**ADDENDUM  
NO. 1**

**June 5, 2024**

**Connersville High School & Frazee Elem. Renovations  
1100 Spartan Drive – High School  
600 West Third Street – Frazee Elem.  
Connersville, IN 47331**

**Addendum One (AD.01)** to the drawings and specifications prepared by Gibraltar Design for **Frazee Elementary School and Connersville High School Natatorium Renovations** for Fayette County School Corporation, Connersville, Indiana.

**A M-101F**

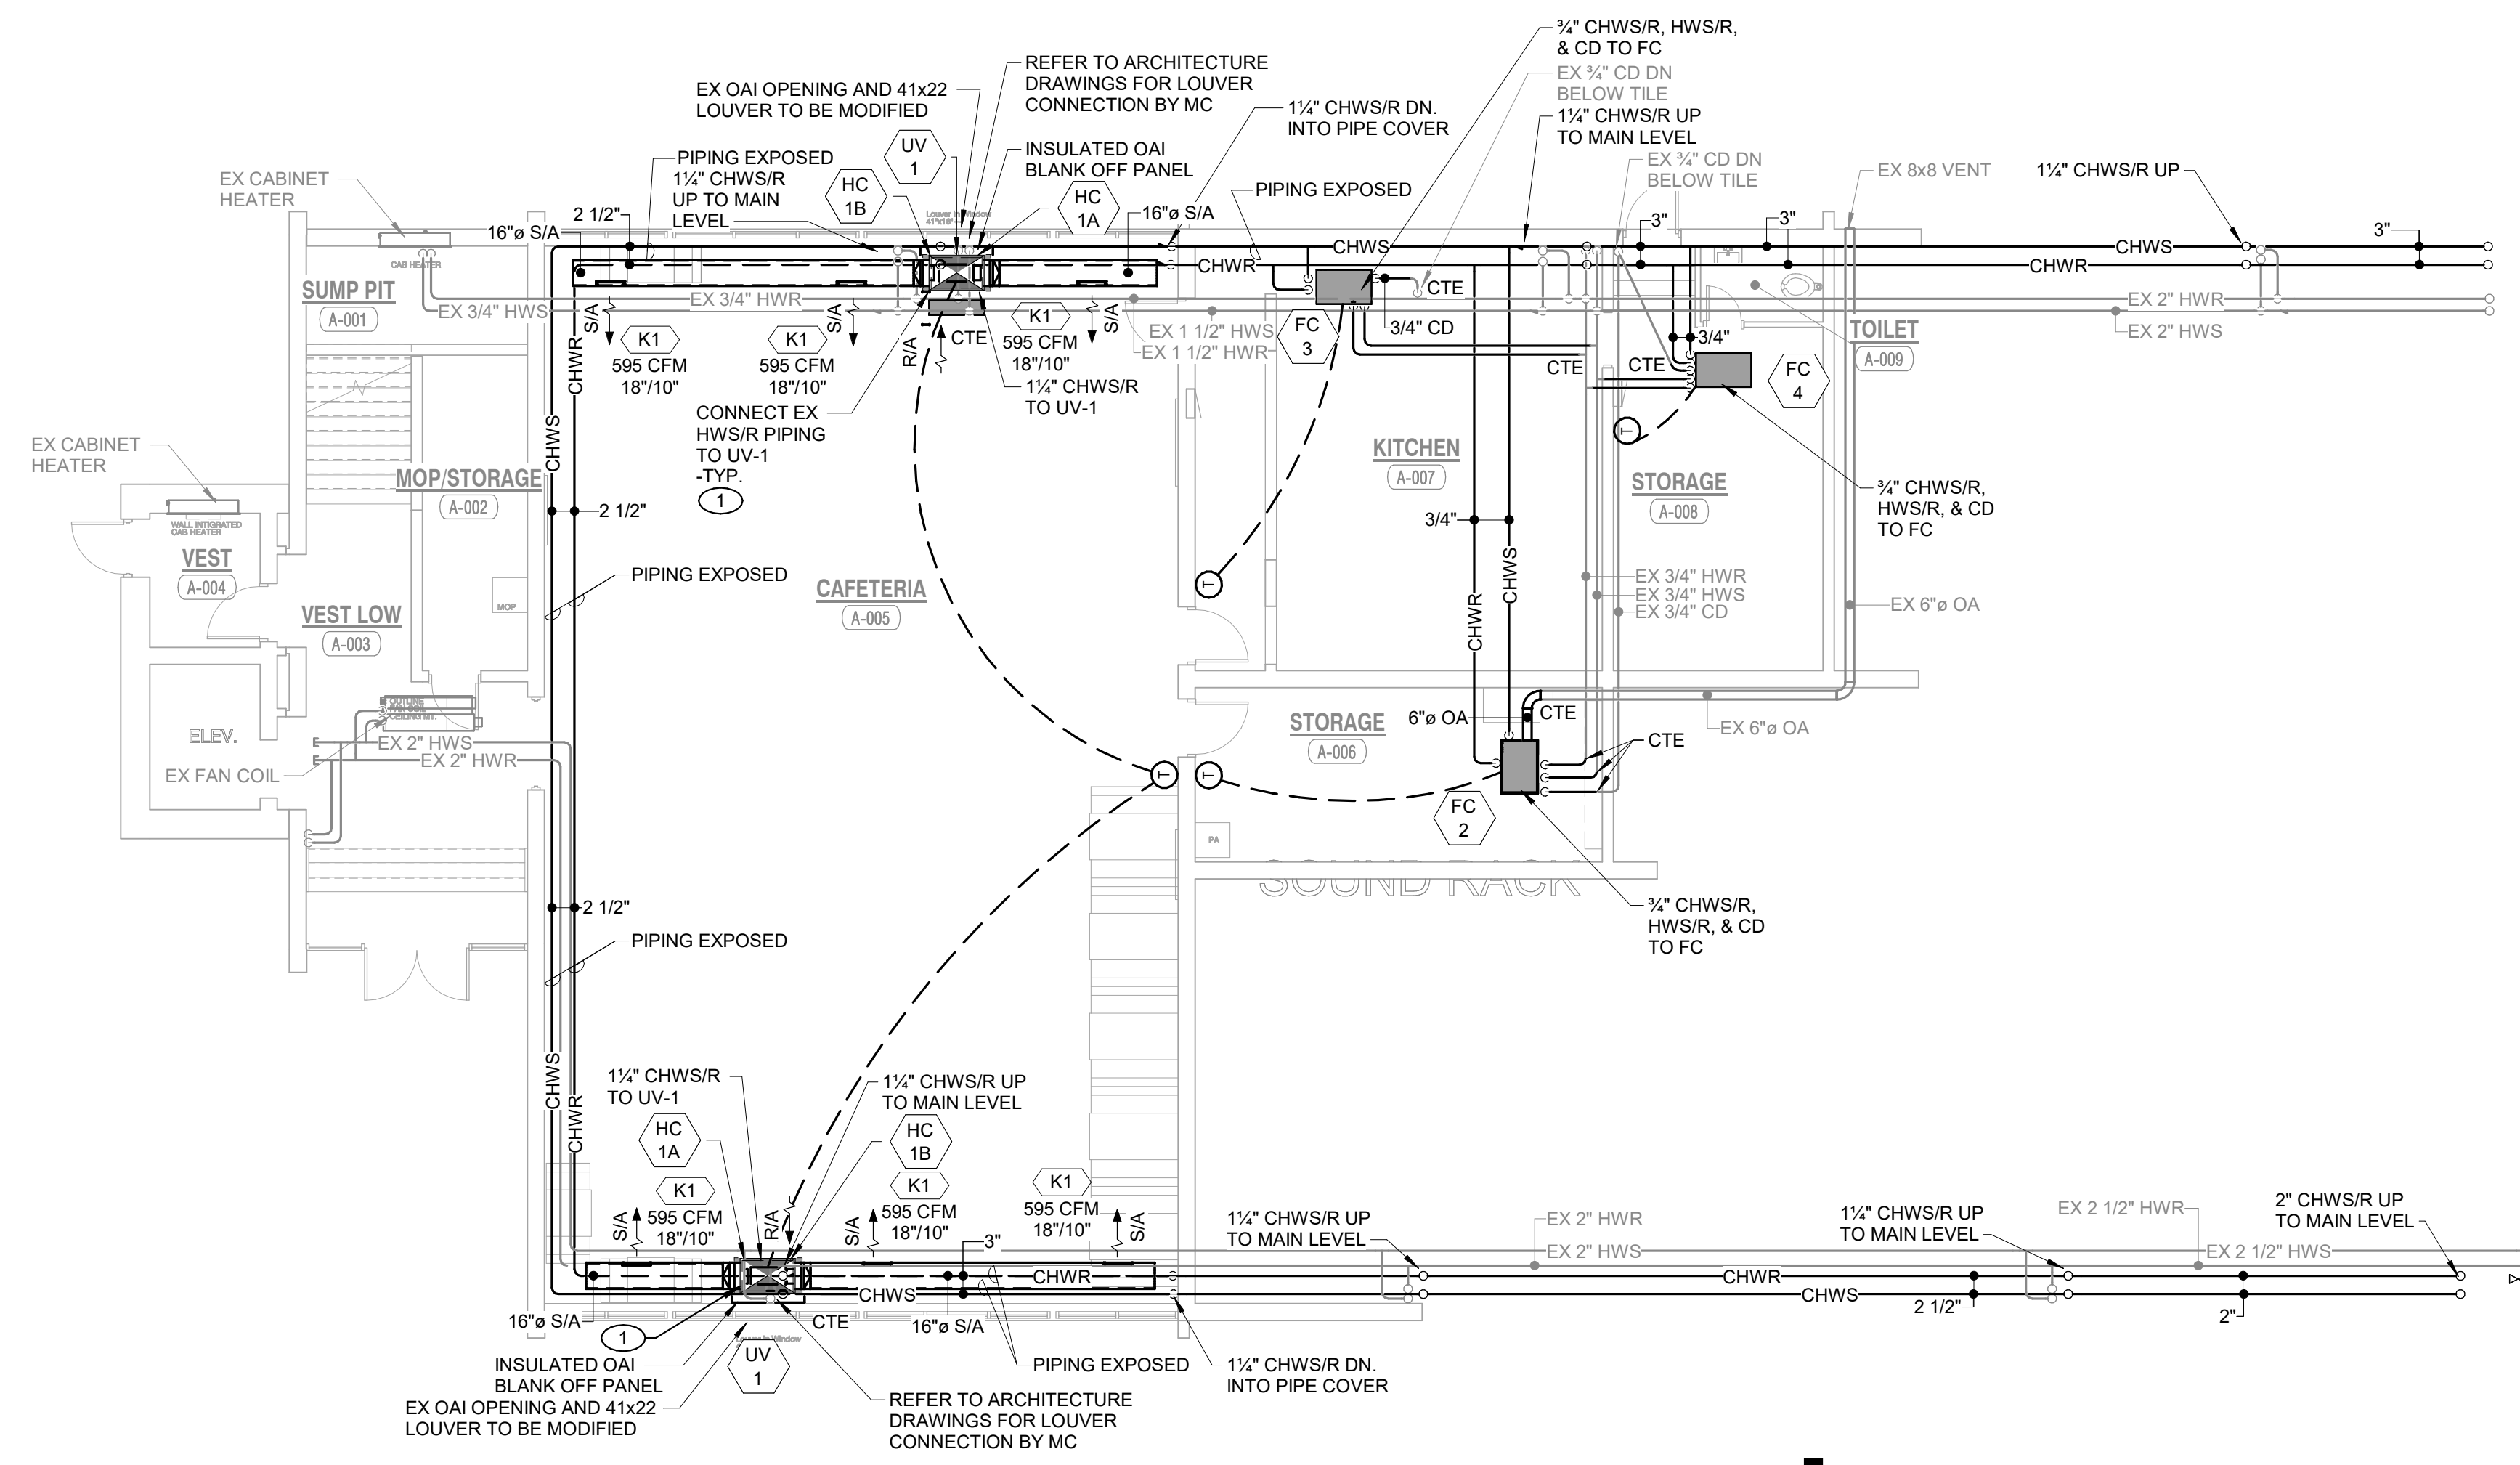
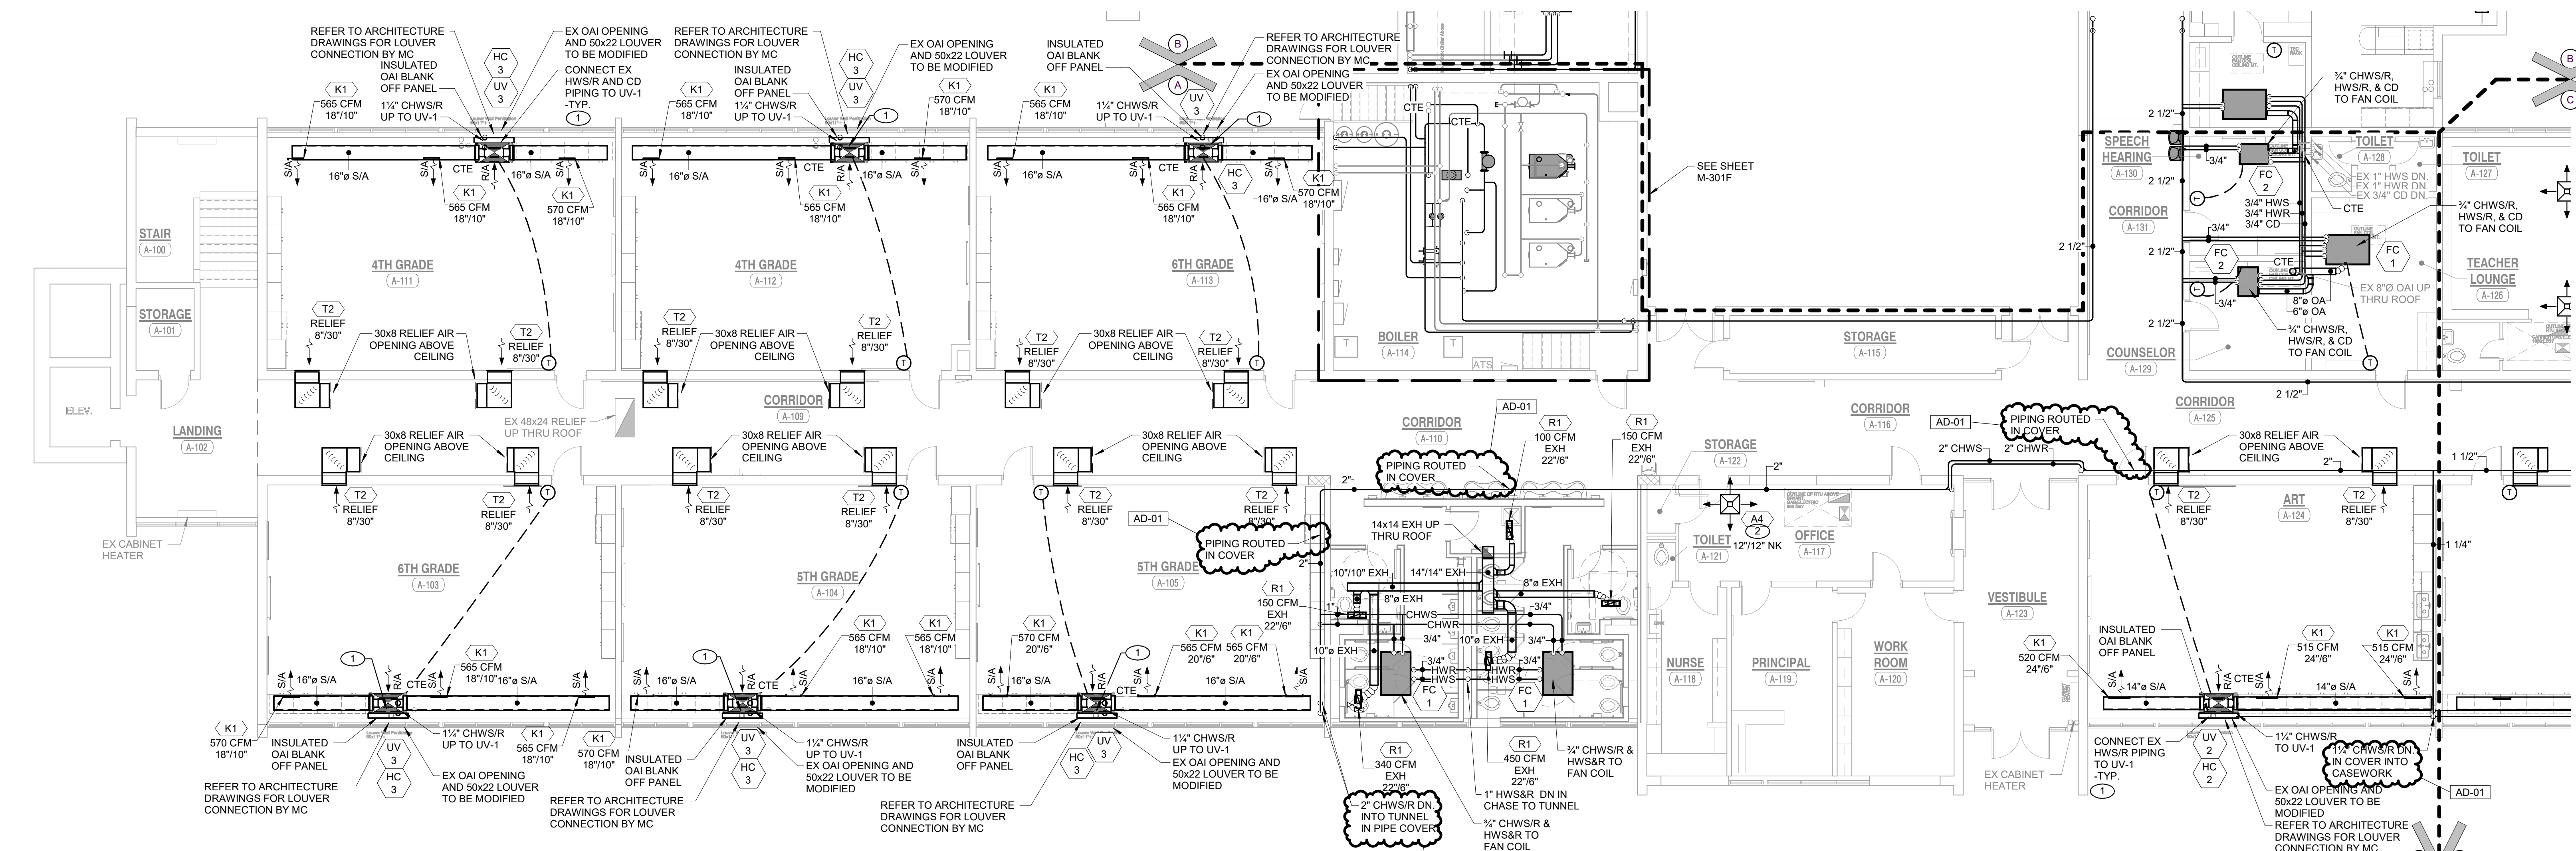
- 2. Sheet M-101F, M-102F, M-103F**
  - A. Refer to three (3) revised full size drawing included in this addendum, for added pipe cover notes.
- 3. Sheet M-301F**
  - A. Refer to revised full size drawing included in this addendum, for the following revisions:
    1. Add demolition notes to sheet note box for hot water pumps, chemical treatment, and bypass filter.
    2. Hot water pumps and chemical treatment to be removed and notes.
    3. Add new hot water pumps, chemical treatment, and notes.
- 4. Sheet M-501F**
  - A. Refer to revised full size drawing included in this addendum, for HWP-1 and HWP-2 added to pump schedule.
- 5. Sheet M-601F**
  - A. Refer to revised full size drawing included in this addendum, for added piping support detail.
